# EAST TOWN CROSSING FRONTAGE IMPROVEMENTS

## COVER SHEET

# EAST TOWN CROSSING SHAW ROAD IMPROVEMENTS

EAST TOWN CROSSING PIONEER WAY IMPROVEMENTS  
SEC. 26,35/ TWP. 20 N./ RGE. 4 E., W.M.

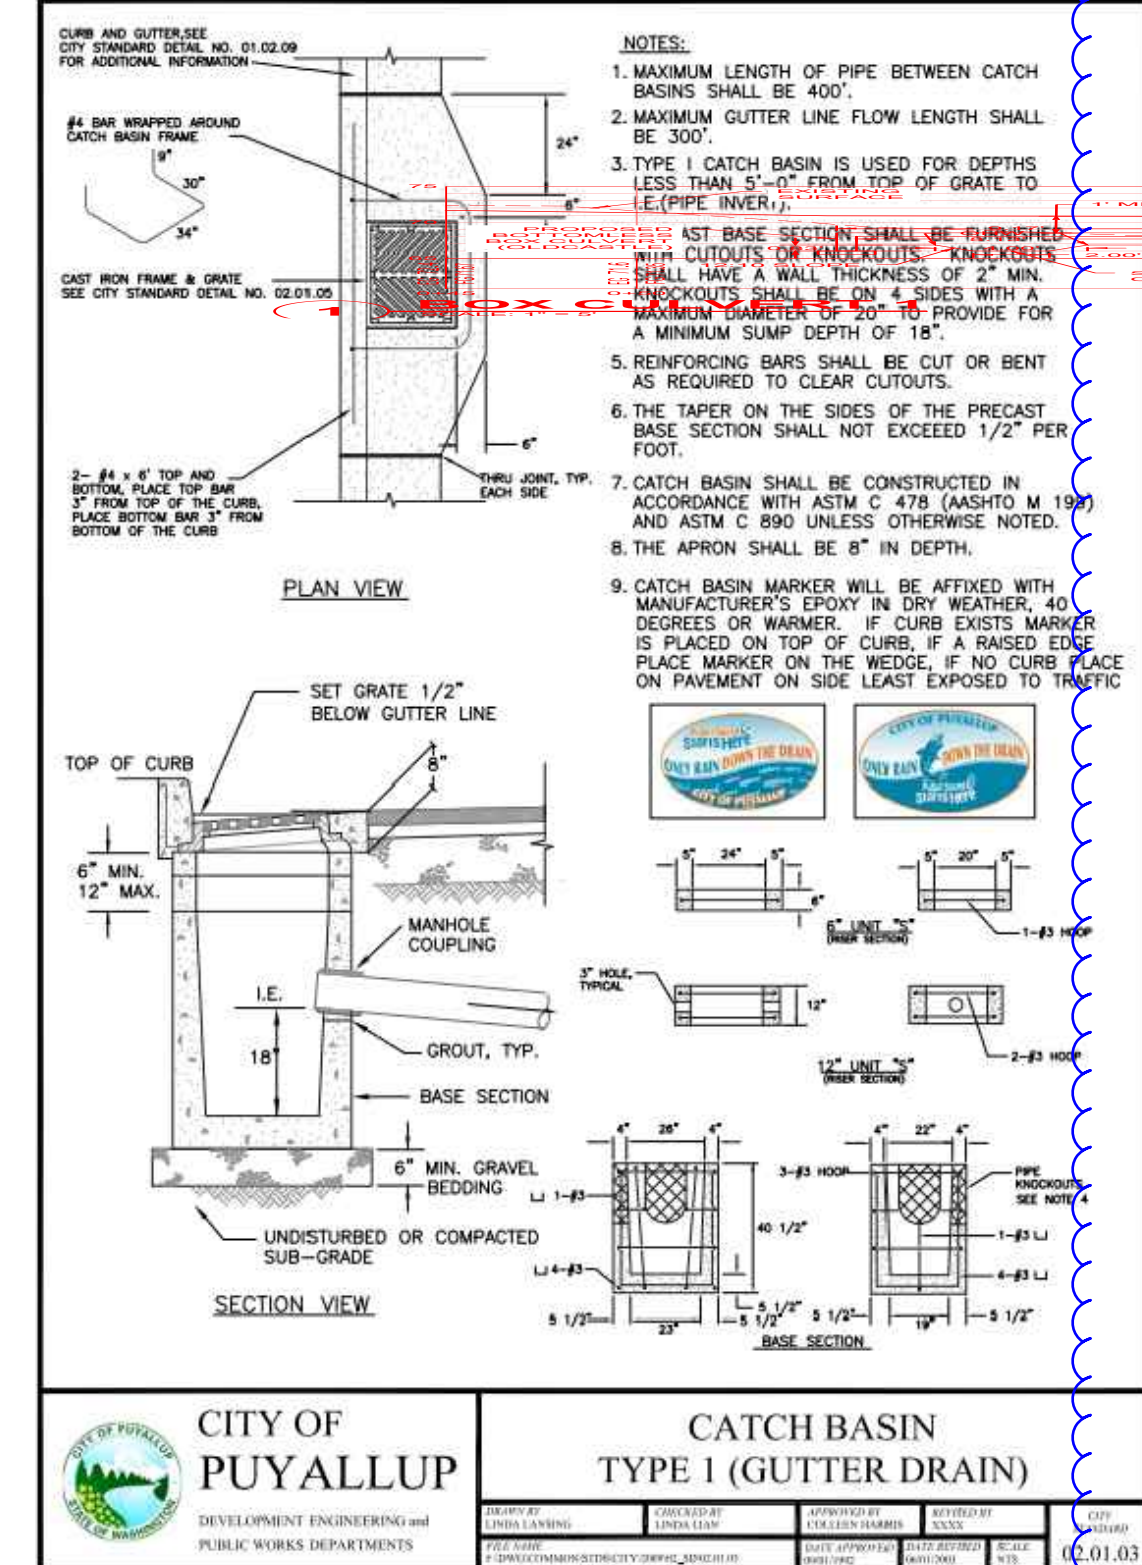
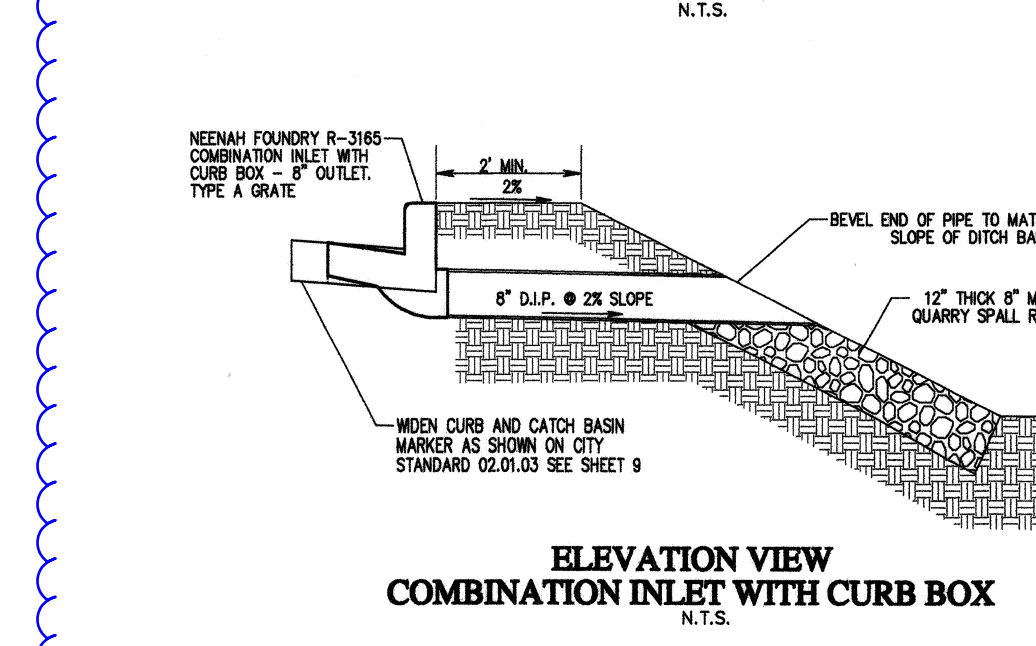
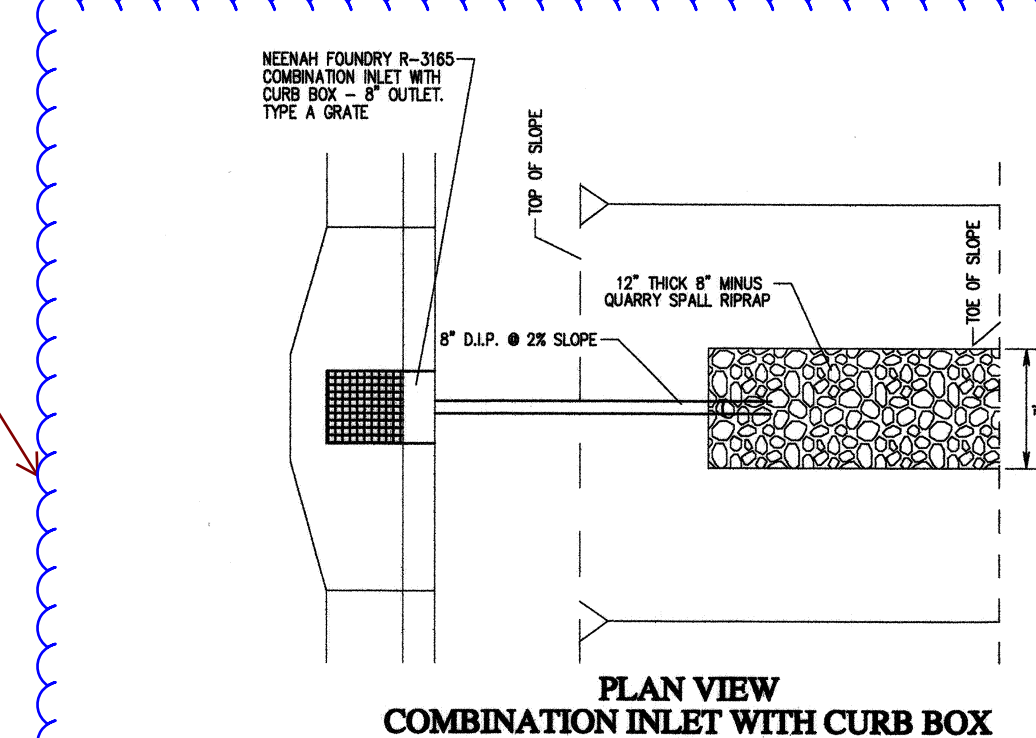
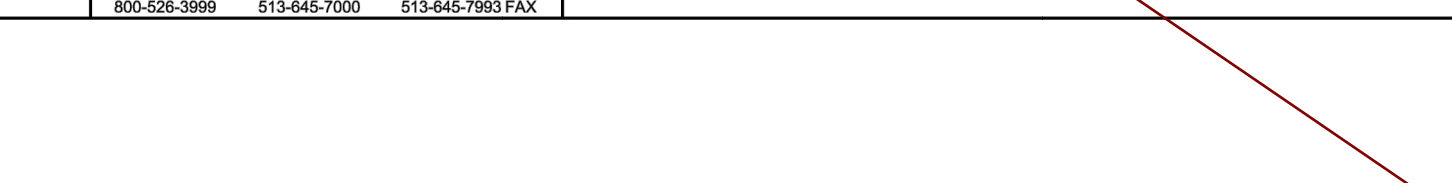
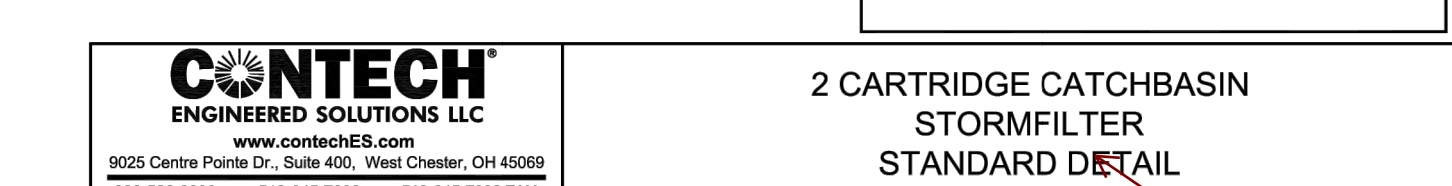
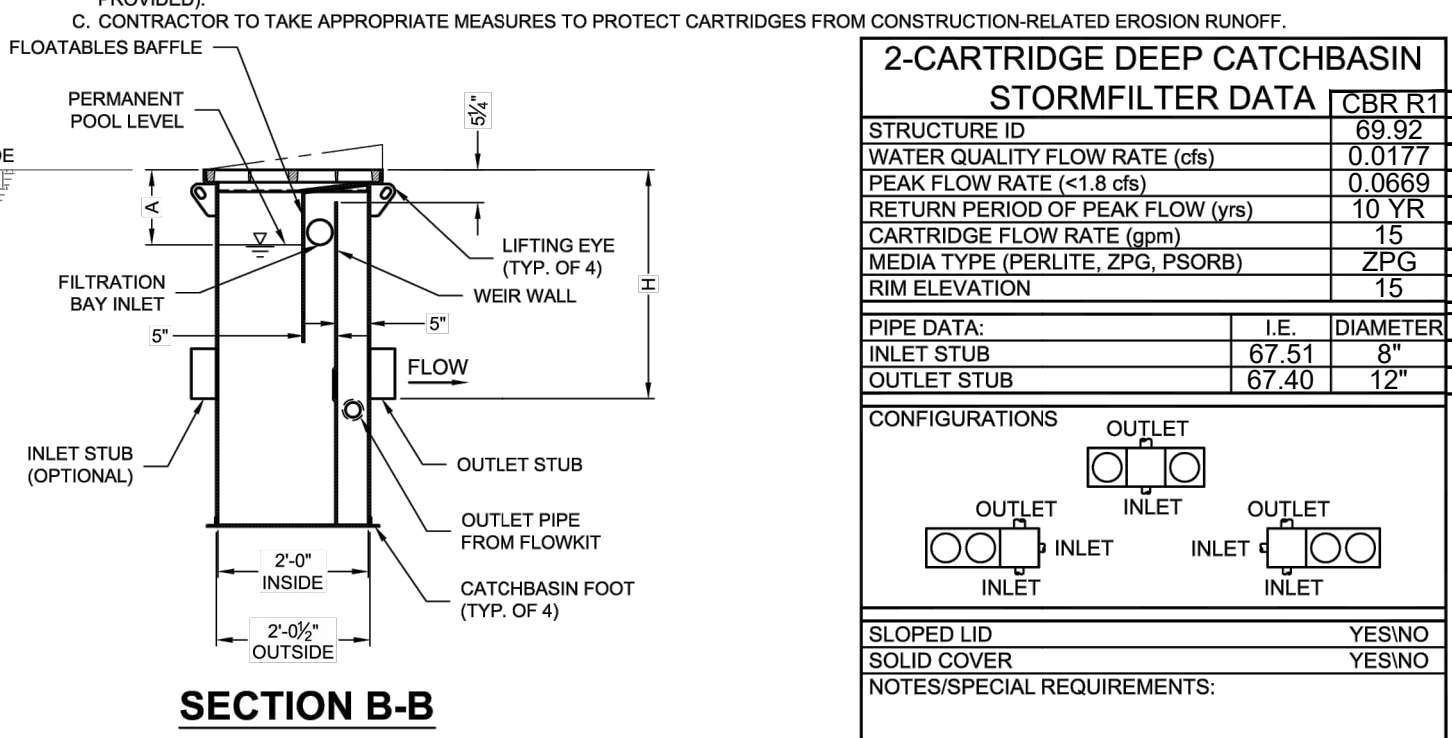
Provide maintenance access above pipe-culvert to-in. (See example above as on possible alternative). [Plans; Sht R6.2 of 21]

Provide CIP or prefab end wall. If CIP call out reinforcing rebar. (See example above as on possible alternative). [Plans; Sht R6.2 of 21]

Verify-HPA culvert details indicate 2ft tall interior height. [Plans; Sht R6.2 of 21]

Enhanced Treatment required for Pioneer. The comments below are provided in case the biofiltration swale will still be utilized as part of a treatment train. [Plans; Sht R6.2 of 21]

Callout grass on the side slopes. [Plans; Sht R6.2 of 21]

Confirm 5/8" minus per Ecology. [Plans; Sht R6.2 of 21]

Callout the following information for the WQ swale:  
-grass seed mix criteria  
-thickness of amended soil  
-amended soil composition criteria  
-filter fabric wrap reqts.  
-drain rock thickness above/below underdrain  
-indicate groundwater elev (EI: 69.84) in relation to the x-section  
-indicate synthetic impermeable liner and provide criteria. [Plans; Sht R6.2 of 21]

Due to the configuration of the Contech Stormfilter CB, the location of the outlet places the CB perpendicular to the curbline and into the travel lane. City Standards 204.8(11) does not allow solid square lids in the travel lane. Either replace the proprietary square lid with round lids or provide an alternative device (see Old Castle Park Filter as an example). [Plans; Sht R6.2 of 21]

Add City Std Details: 02.01.05 // 06.01.01 // 06.01.02 [Plans; Sht R6.2 of 21]

added to new sheet: R6.3
